**TO:** Bob Exstrom, Town of Parker  
**FROM:** Stacey Nerger, Senior Planner  
**DATE:** April 23, 2024  
**SUBJECT:** Parker Town Hall Amendment 3 Lot 1 – Site Plan  
Review Comments 03

# PARKER TOWN HALL EXEMPTION PLAN AMD3 L1

### Parker Town Hall Expansion

#### SITE PLAN

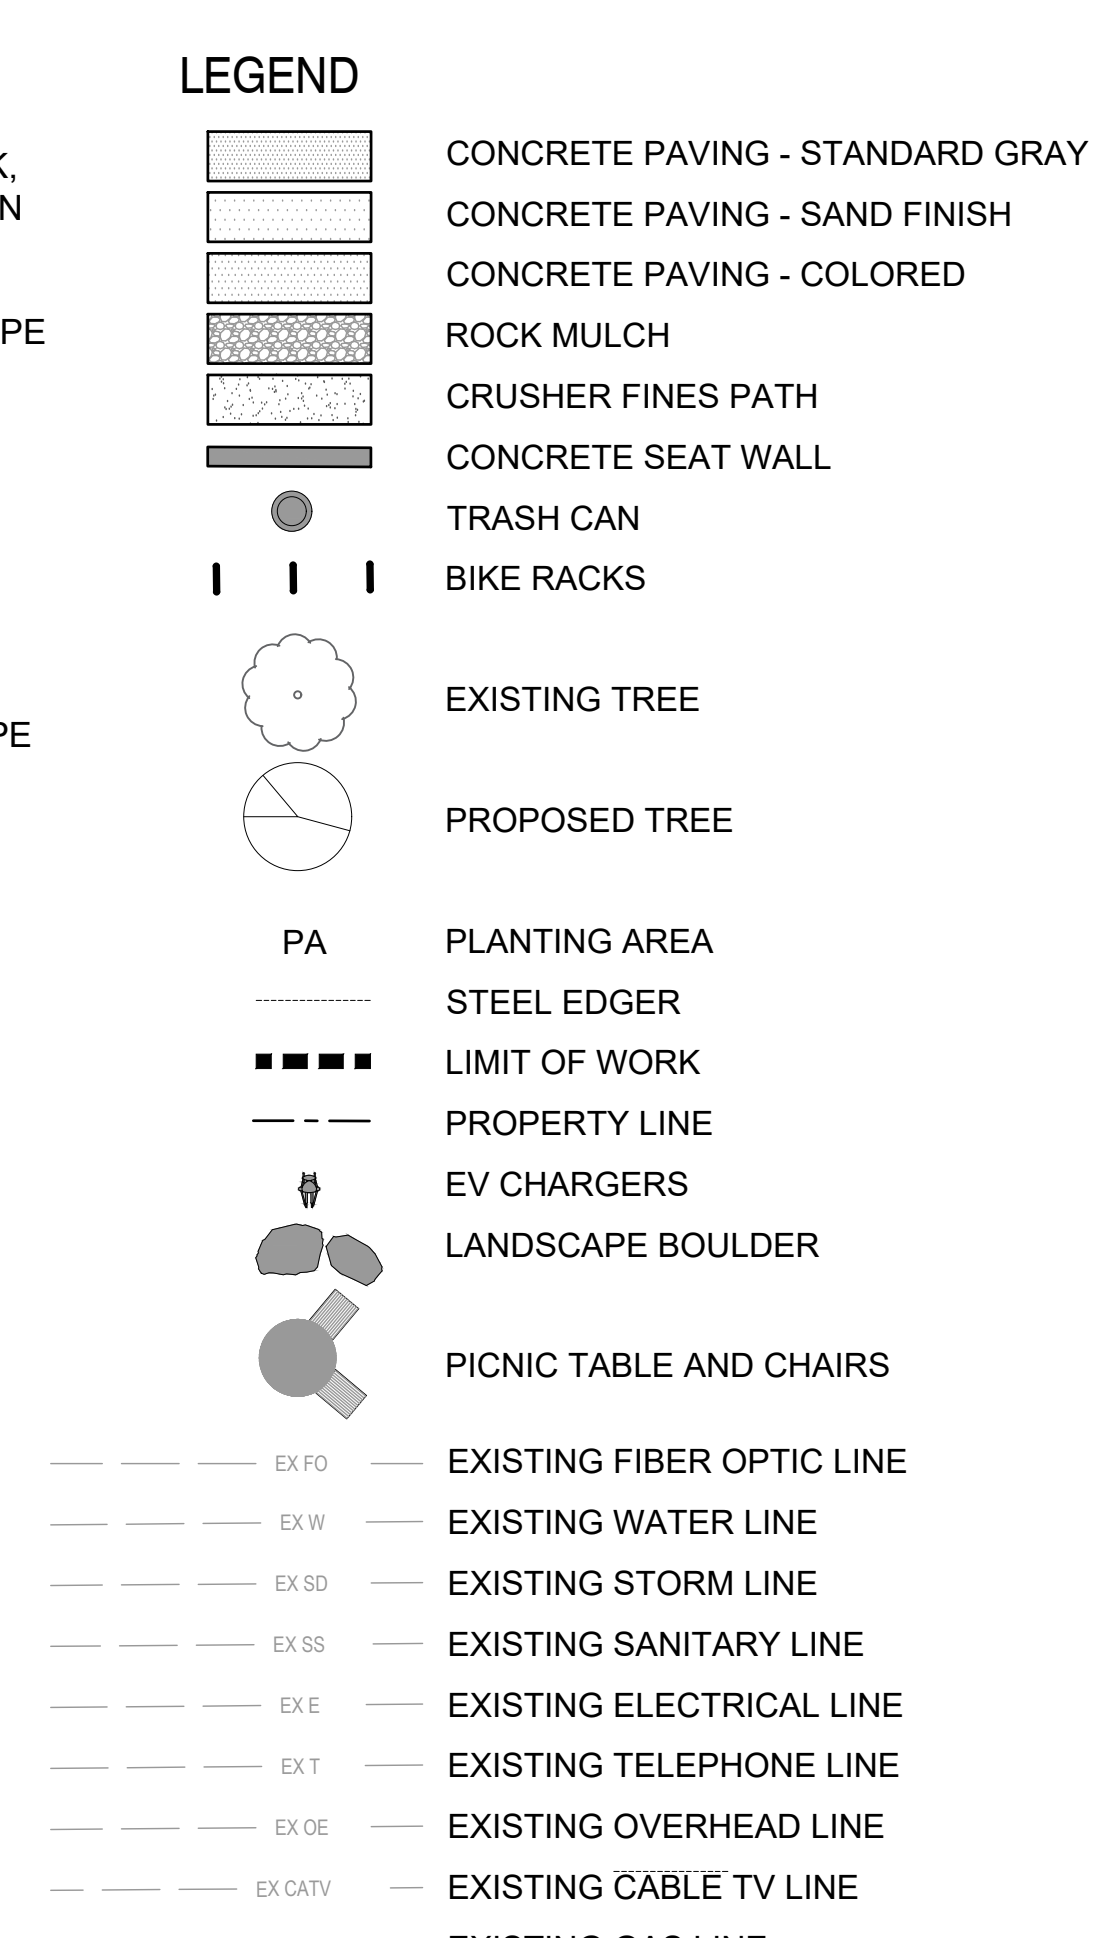
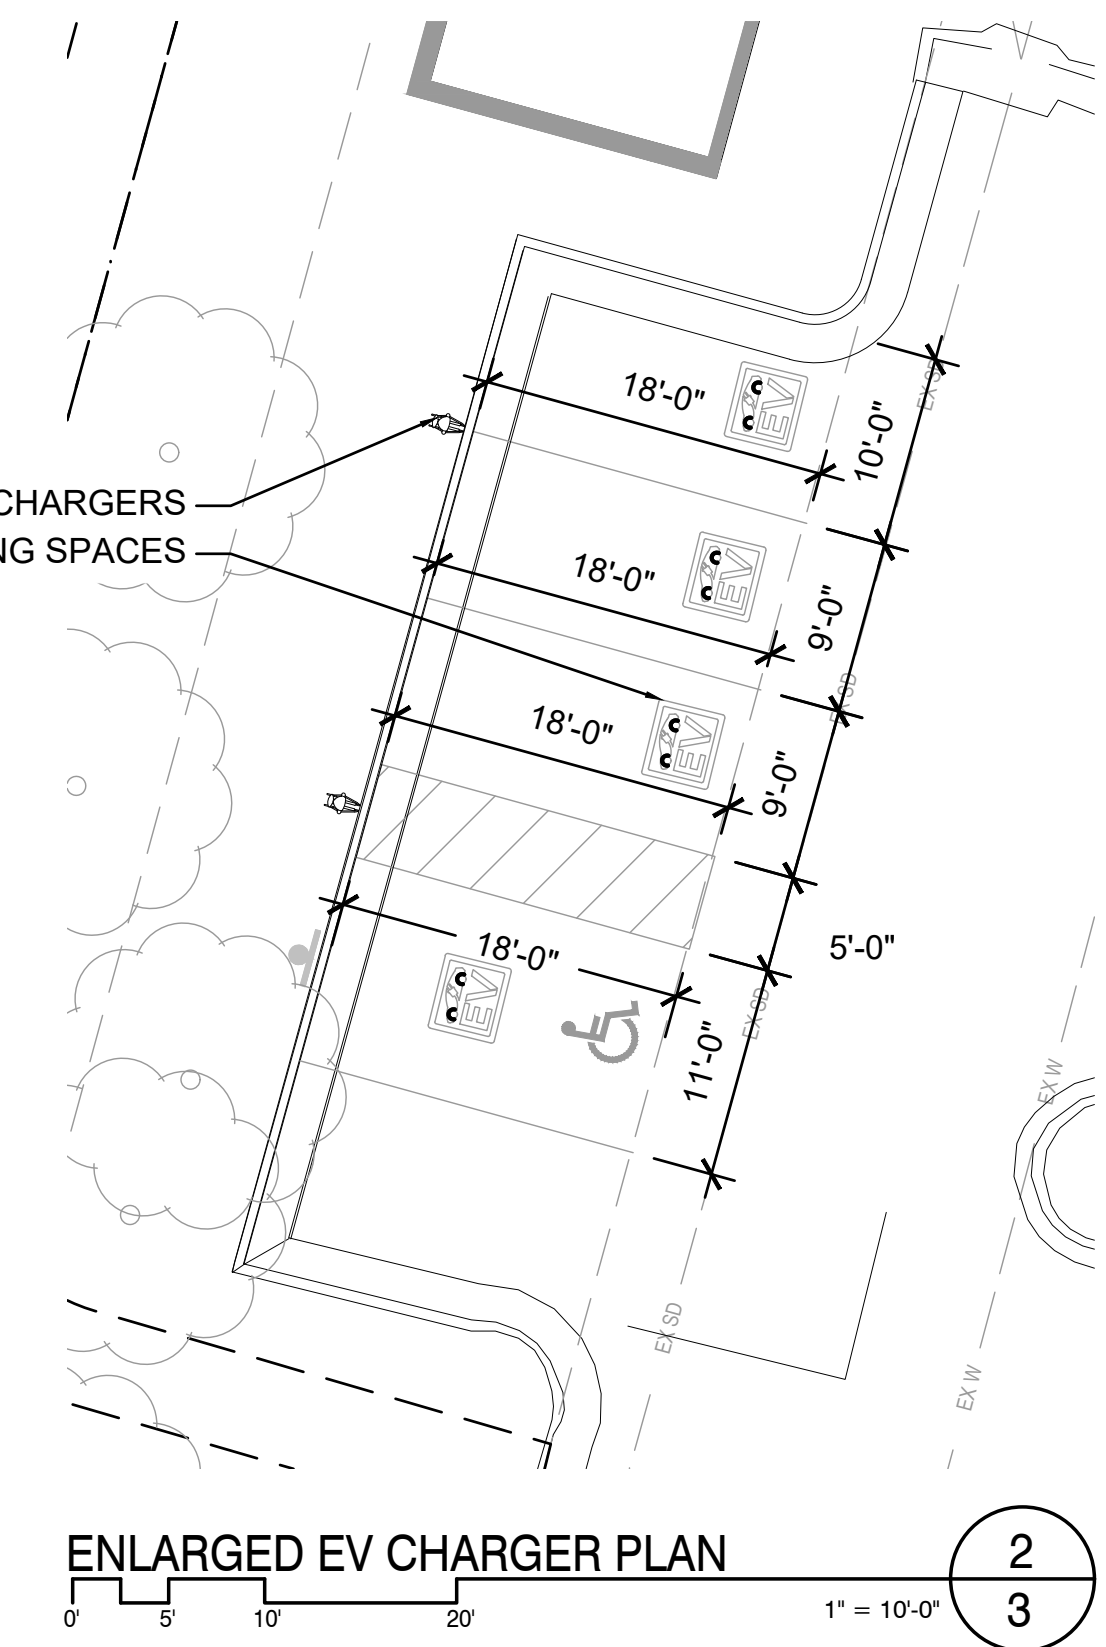
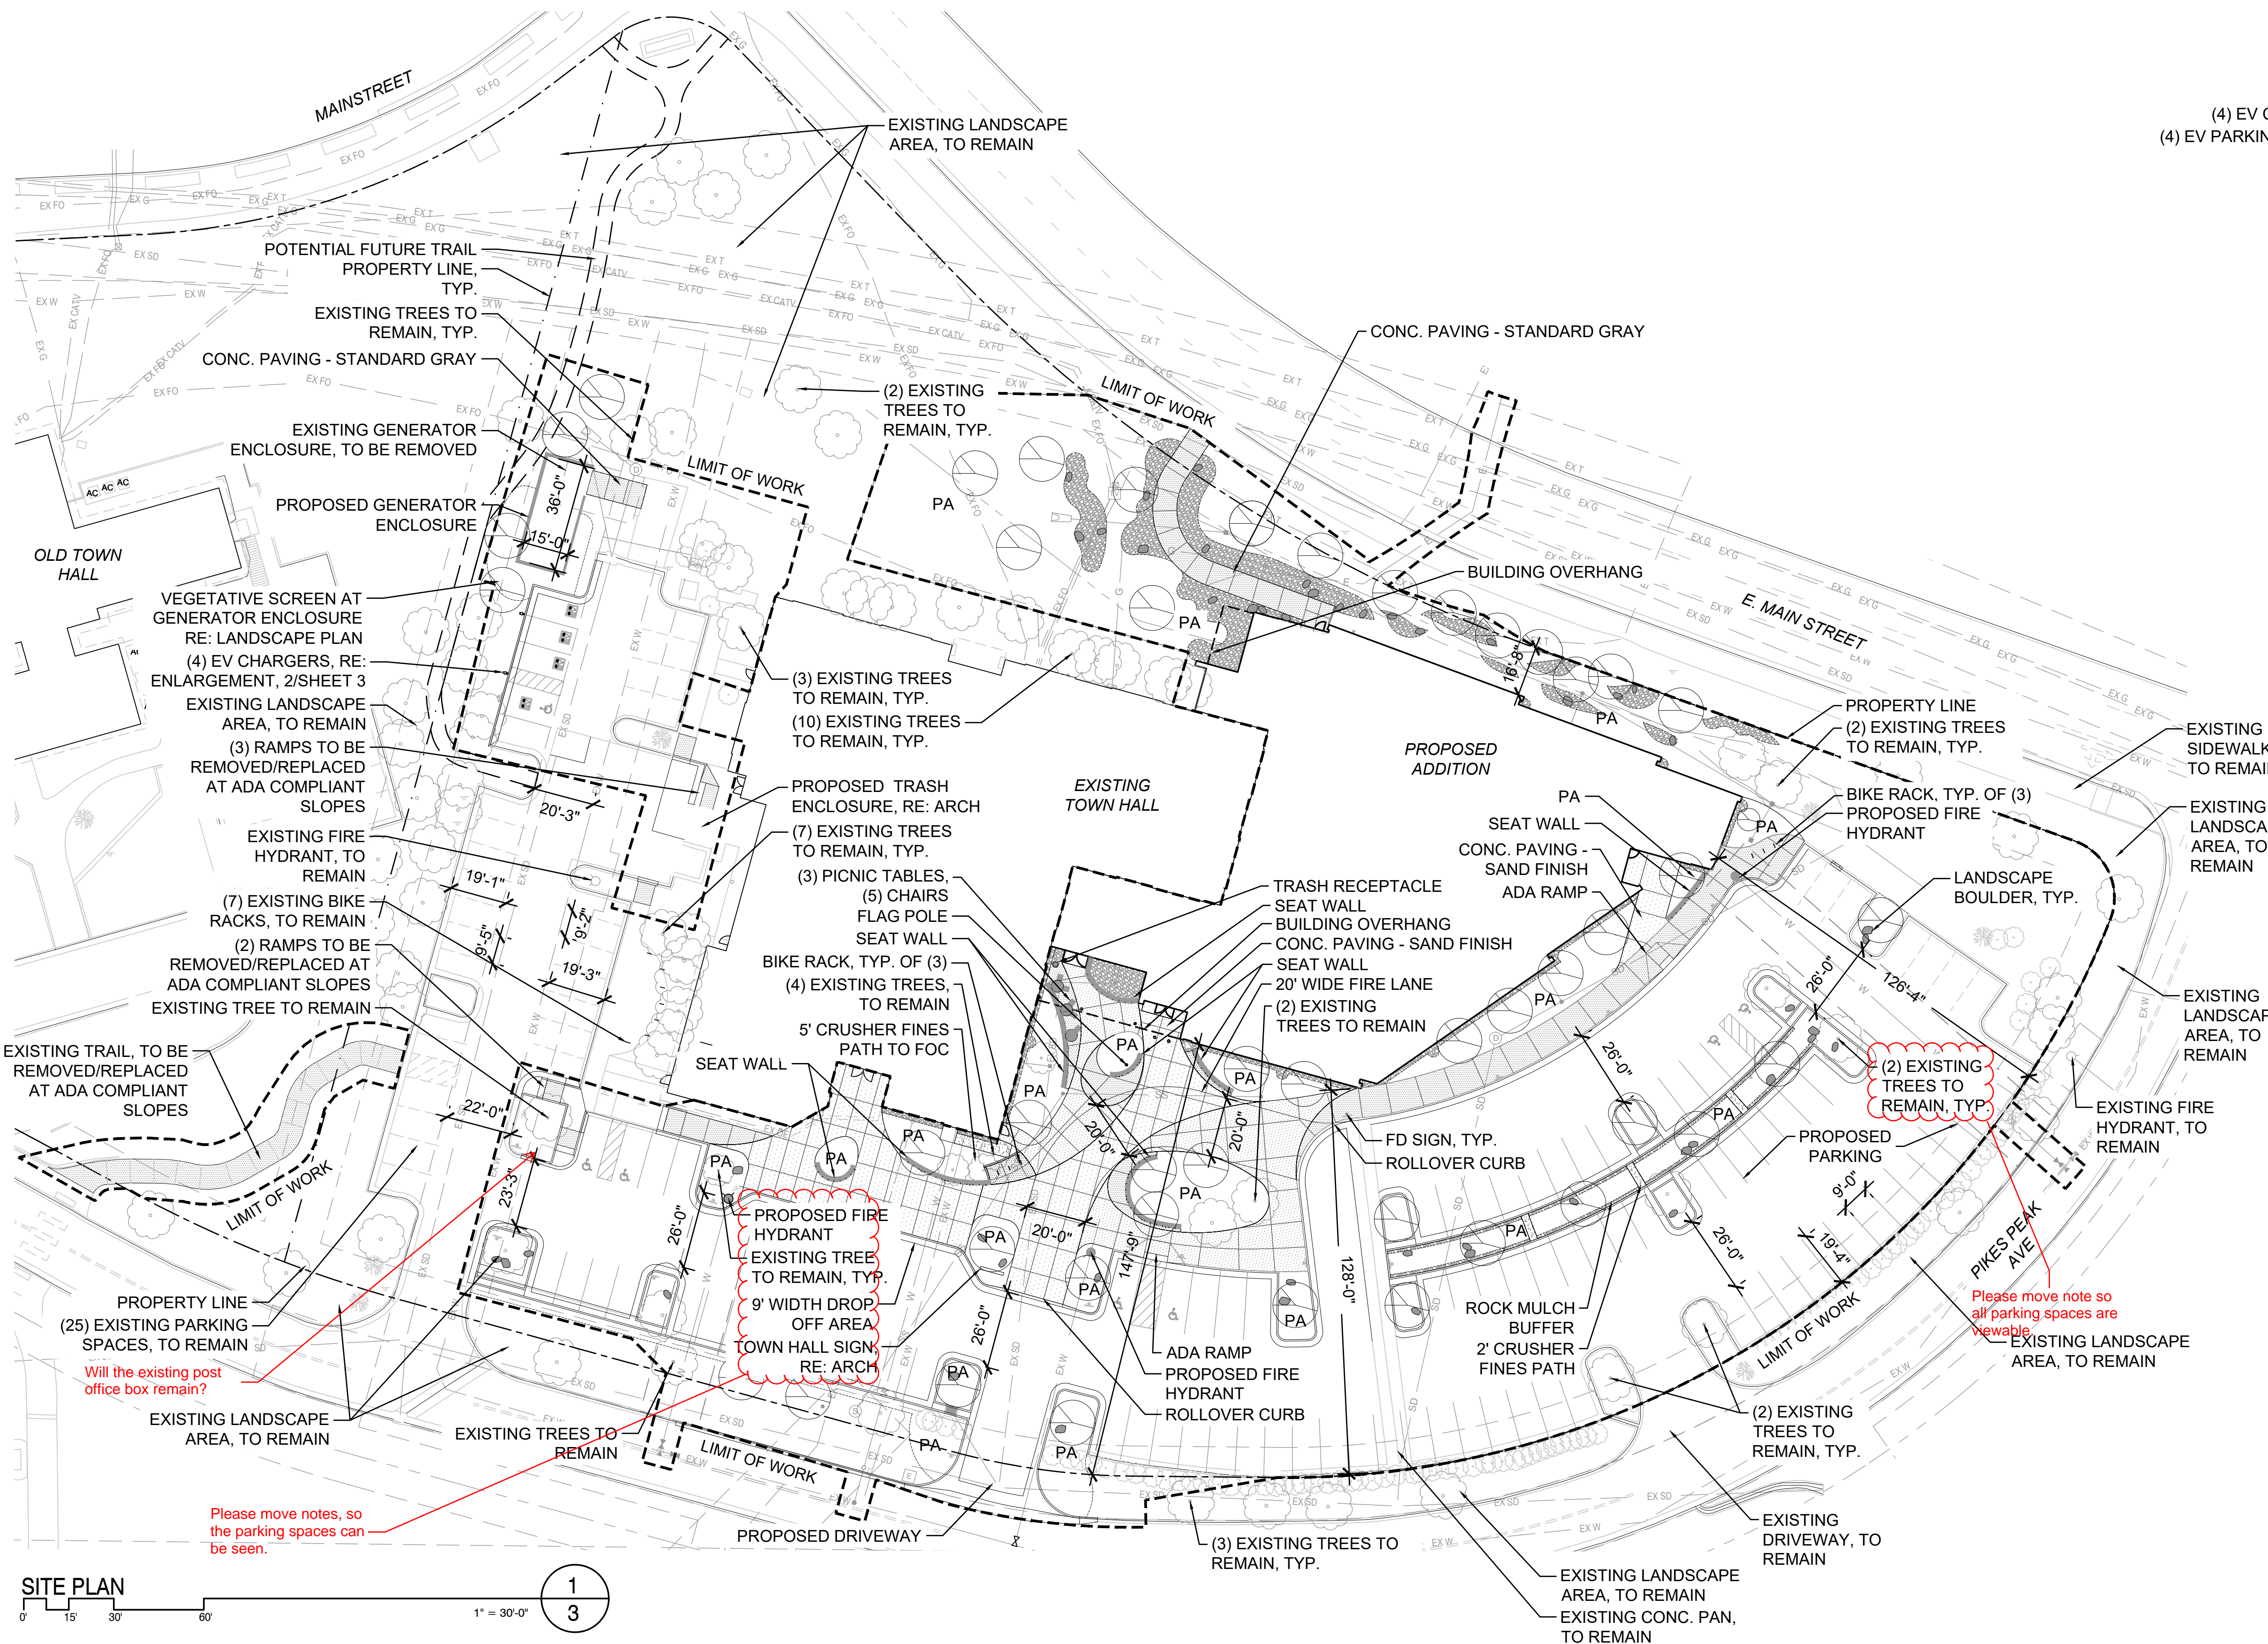
2. Please make sure all parking spaces proposed on site are shown on the overall site plan. There are several areas where text interferes with the locations.

Add parking spaces adjacent to landscape islands. These spaces need to either be 10' in width or the island needs to include an 18" concrete step out strip. If you are using the 18" concrete strip, please add a note below table and leave as currently written.

Change this to be the actual parking spaces provided with EV chargers. Also, please remove these spaces from the typical parking spaces as the numbers don't work. Understand that there is a note to clarify, but it would be cleaner to just removed the EV spaces from the typical spaces.

**LANDSCAPE REQUIREMENTS DIAGRAM**

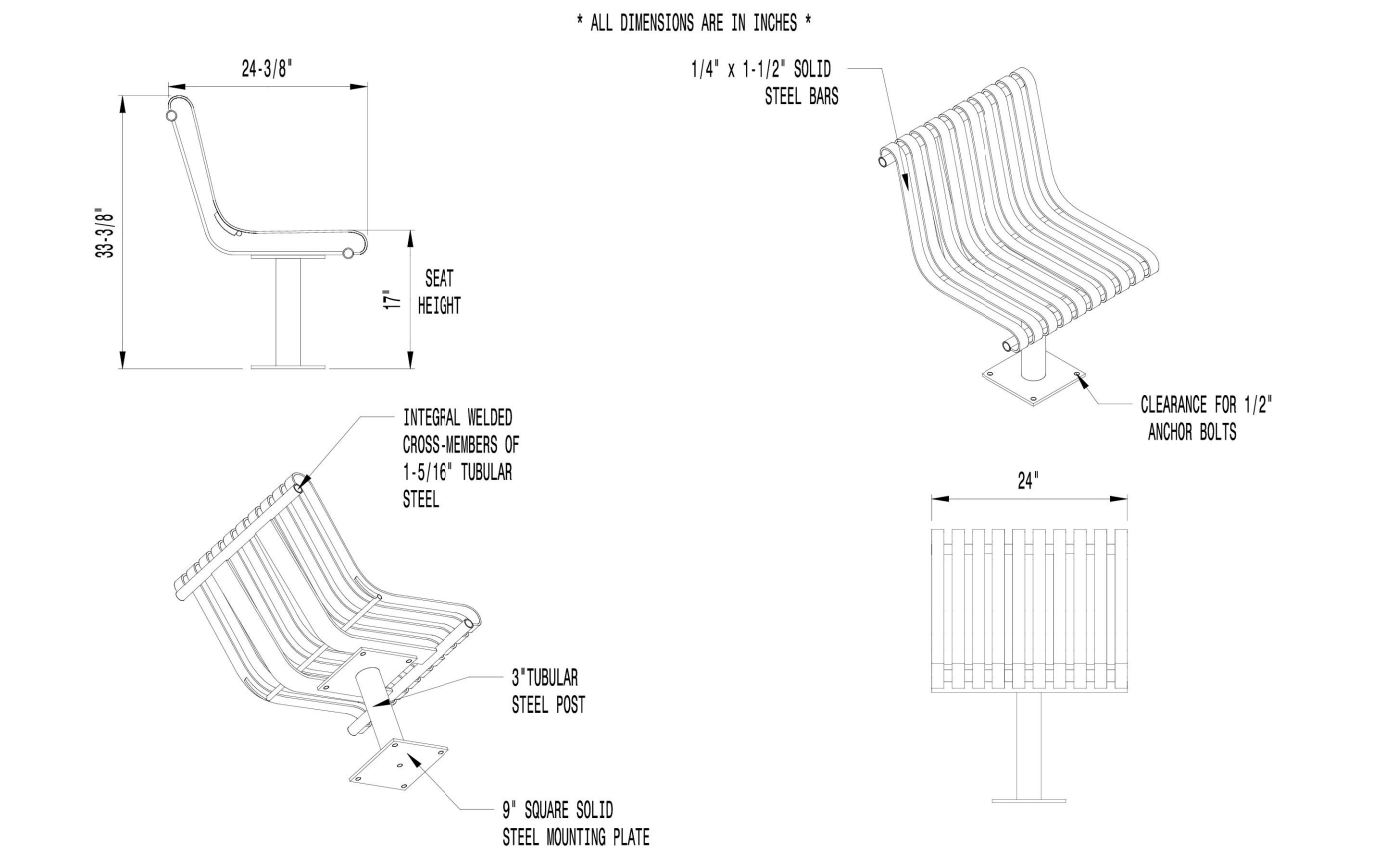
Required shrubs are calculated as 5 are required for the first 162 s.f., then 1 additional shrub is required per every 15 s.f. additional. This one would therefore, require 9.  
 $227 - 162 = 65/15=4$   
 $5+4 = 9$

Previous submittals had grasses within the islands. Have these been removed? If these still exist, please add to the notes as they do count towards the minimums.

Per the Town code, parking lot interior landscaping does not count towards the overall site landscaping. Please remove from total number.

Pursuant to the Town of Parker Landscape Standards, 1 tree and 5 shrubs are required for each 1,500 s.f. of landscaping proposed. Based on your numbers, this would require 49 trees and 243 shrubs. The trees and shrubs provided in the landscape islands would be the only trees and shrubs that could not count to meet these minimum requirements.
